CERTIFICATE OF APPROPRIATENESS

Property: 1011 Peddie Street, Lot 16, Block 109, North Norhill Subdivision. The property includes a historic 1,160 square foot historic one-story wood frame single-family residence and detached garage situated on a 5,000 square foot (50' x 100') interior lot.

Proposal: Alteration – Addition.

Recommendation: **Approval with conditions: Relocate the new door from the original structure to the addition or in the original window opening.**

WEST SIDE ELEVATION

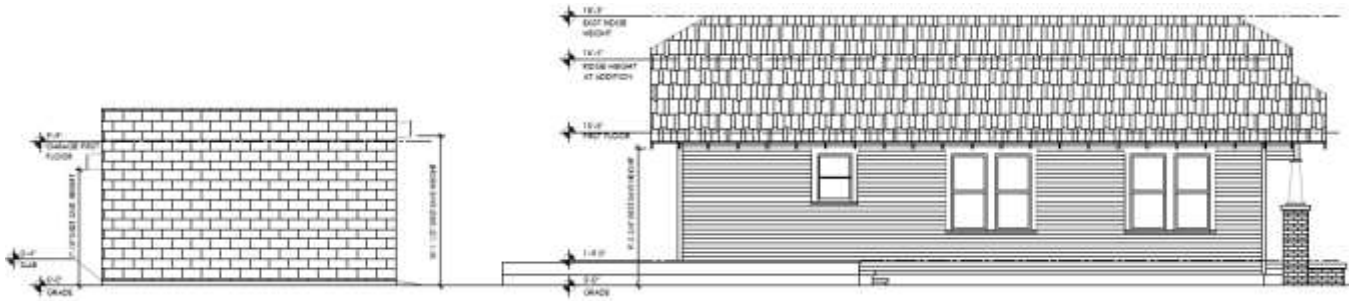
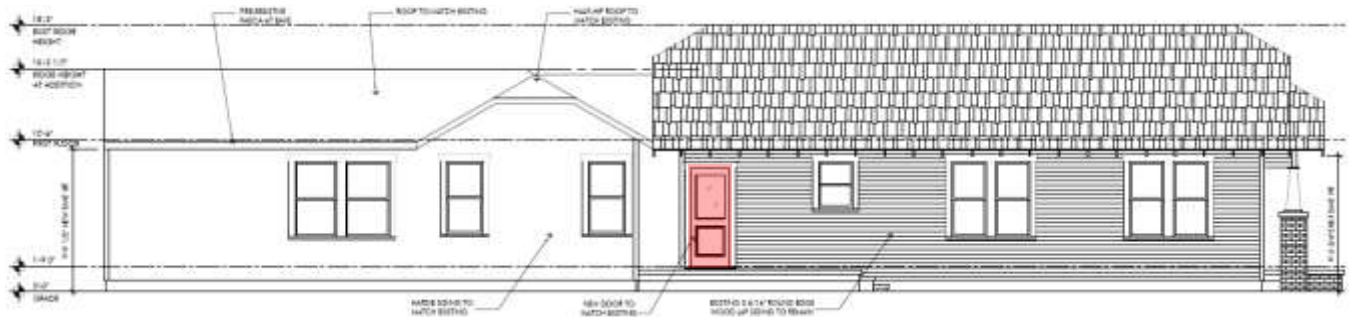
<i>Although there was a window at the rear of the west elevation that has previously been closed in, the installation of a door near this location will lead to the damage of surrounding original material. Staff recommends that the proposed door be installed in the original window opening or be installed in the addition in order to preserve original material.</i> |

<i>Although there was a window at the rear of the west elevation that has previously been closed in, the installation of a door near this location will lead to the damage of surrounding original material including siding, shiplap, and framing. Staff recommends that the proposed door be installed in the original window opening or be installed in the addition in order to preserve original material.</i> |

PROPOSED SIDE DOOR LOCATION

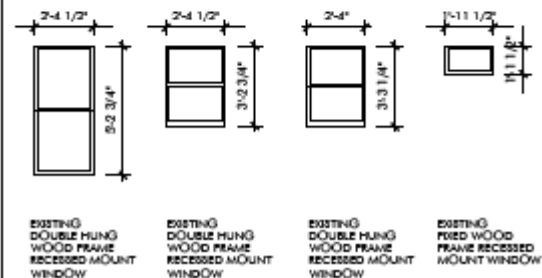
<i>Installation of a door near a previously closed in original window opening will lead to irreversible damage to historic material and integrity of the building. Staff recommends that the proposed door be installed in the addition or in the original window opening in order to be reversible and to preserve the original integrity of the structure.</i> |
